Access Compliance Report

Public Rights-of-Way

Intersection ID: 16080	Main Street: BUENA_VISTA_AV	Cross Street: LANIER_AV	Location: E
ADA ID: 65EBC6958DA6	Ramp Type: Directional1	Initial Pass/Fail: Fail	Overall Compliance: No
			Severity Score: 33.75

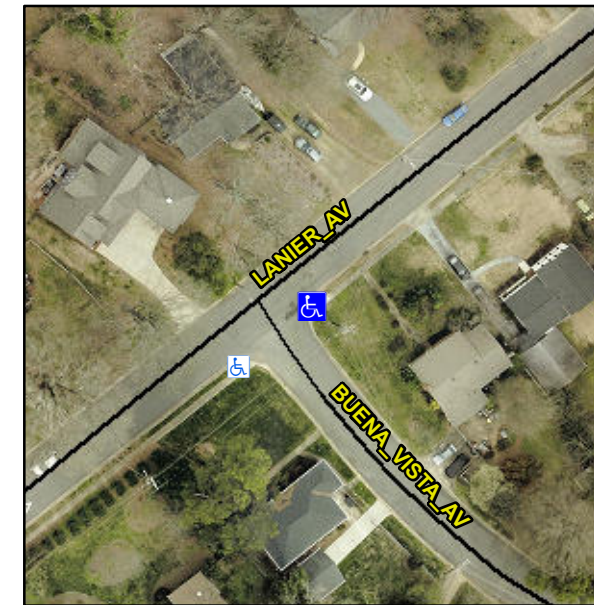
R304.5.1, R304.5.3

Remove & Replace Entire Ramp.
